April 6, 2021

RE: Kiku Crossings Design Modifications

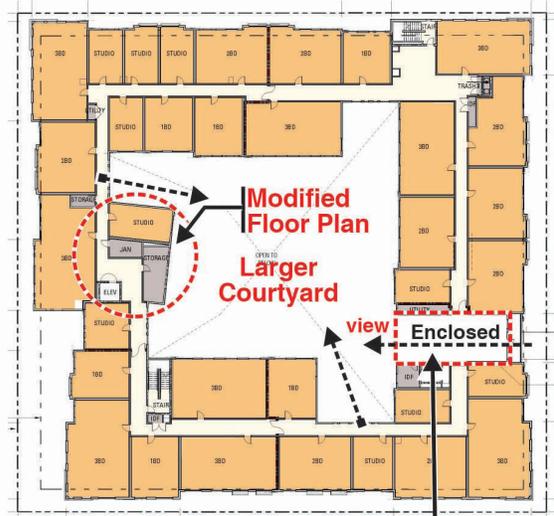
I reviewed the proposed changes to the residential floor plans and elevations. - see comparison illustrations below. Overall, the changes appear minor in regards to the visual qualities of the project. The important changes noted on the illustrations include:

- Increased landscaped setbacks along all sides of the building.
- An improved elevator lobby which will visually open the interior corridor to views of the courtyard.
- Removal of the Fitness Room, and the reconfiguring of the floor plans below that change..
- Modifications to the Community Room.
- Increased open space area within the courtyard.
- Minor modifications to the window arrangements.
- Minor modifications to the elevations at some building corners.
- Added design detail for the building cornice.

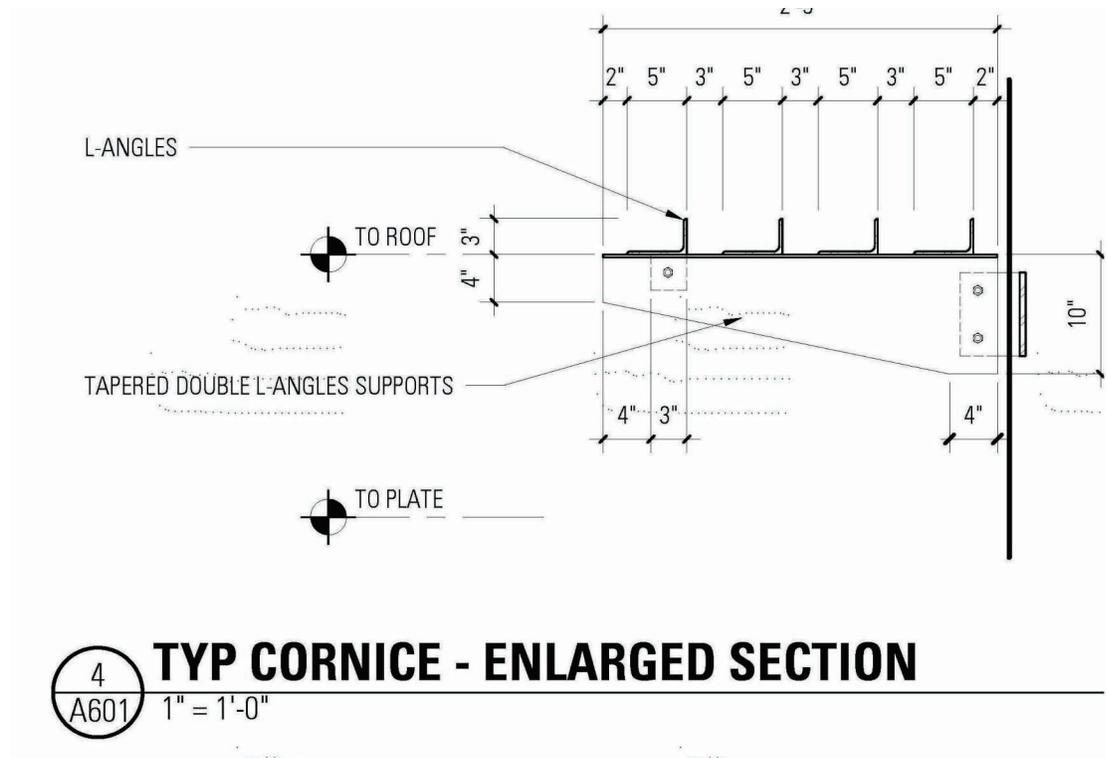
Earlier design submittals did not include a cornice element, but the last drawings that I reviewed prior to the Planning Commission review added them to the building corners - see illustrations below.

In their review of the project, the Planning Commission directed staff to include their preference for a more shaped and detailed cornice in the staff report going to the City Council, and that staff come up with a possible condition of approval that could be imposed at the building permit phase, as reviewed and approved by the Zoning Administrator.

APPROACH A

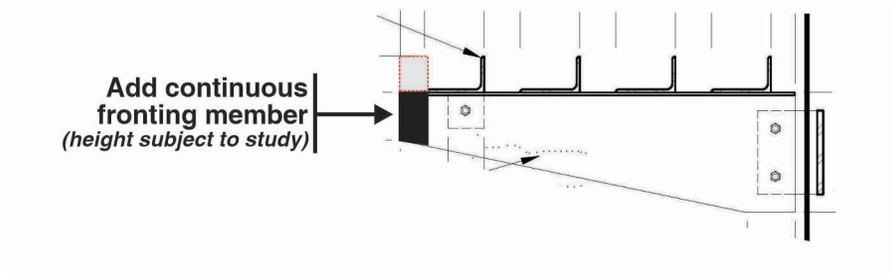
Add beam element at the front of the cornice to give the cornice a stronger, more prominent horizontal felling

APPROACH B

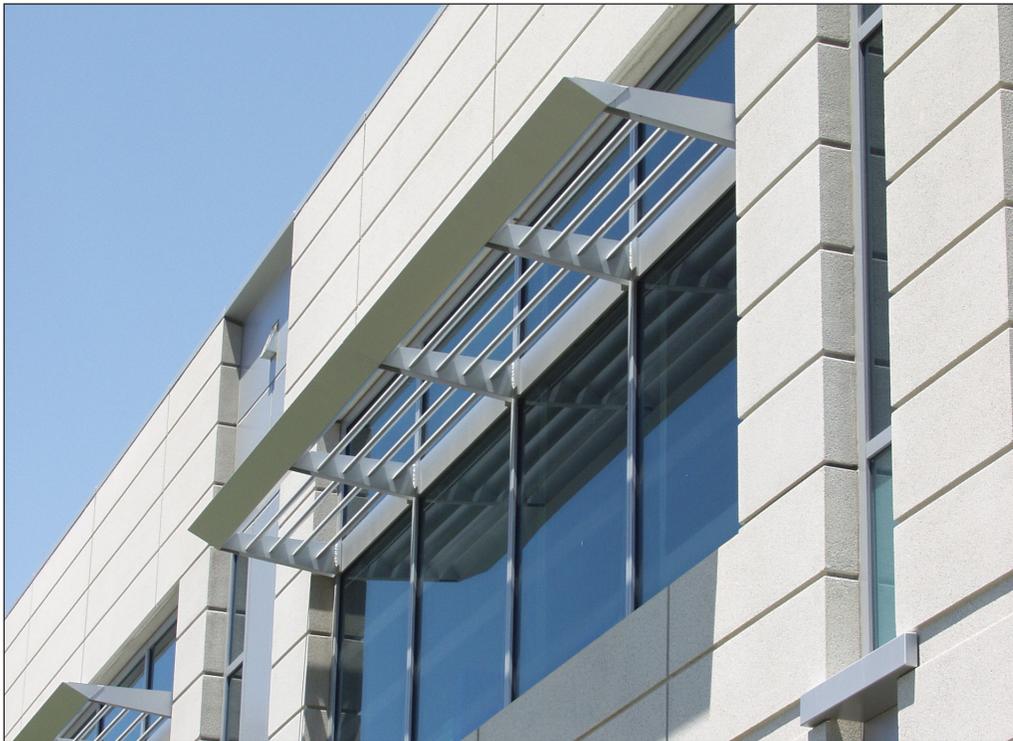
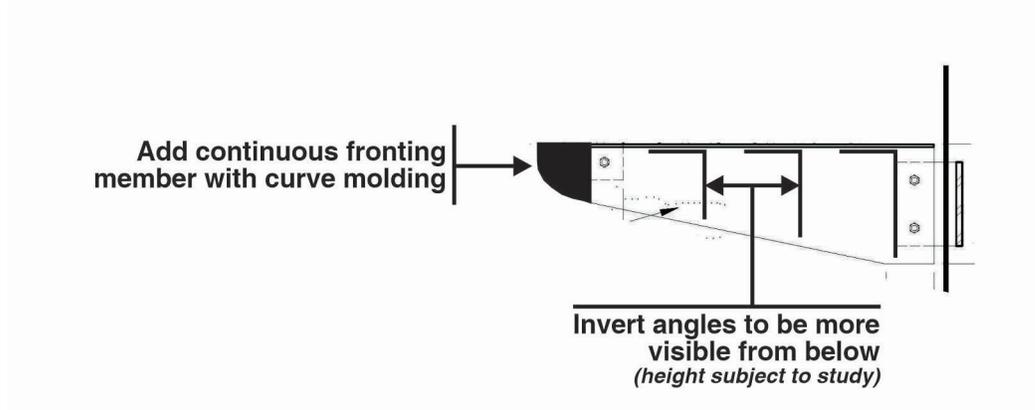
Add a continuous fronting member with curve molding, and lower cross angles to a location more visible from ground level.

APPROACH C

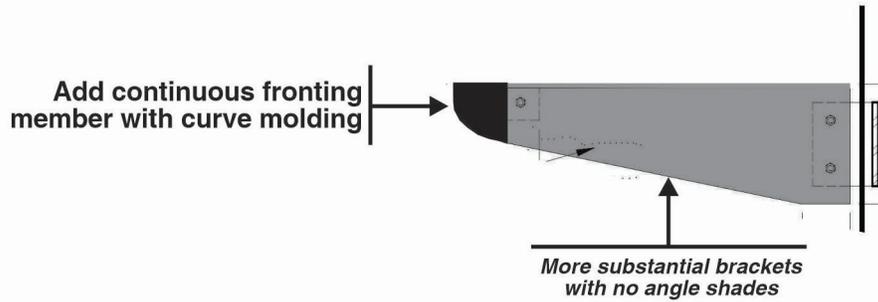
Add a continuous fronting member with curve molding, eliminate the cross angles, and strengthen the size of the projecting support brackets.

PARKING STRUCTURE SOUTH FACADE: AS APPROVED

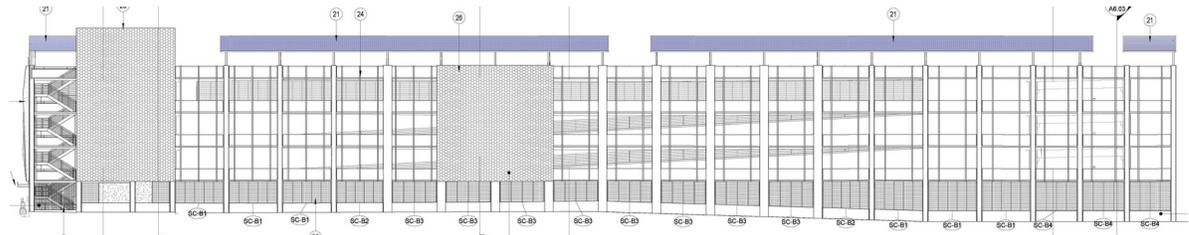
Two concerns have been raised that require some minor modifications to the south facade of the parking structure.

- Potential vandalism to the public art panels at the ground level adjacent to the stairway.
- Potential lack of sufficient exterior facade transparency to allow exterior open air ventilation of the garage rather than more expensive internal garage ventilation.

These changes should not significantly change the appearance of the parking structure.
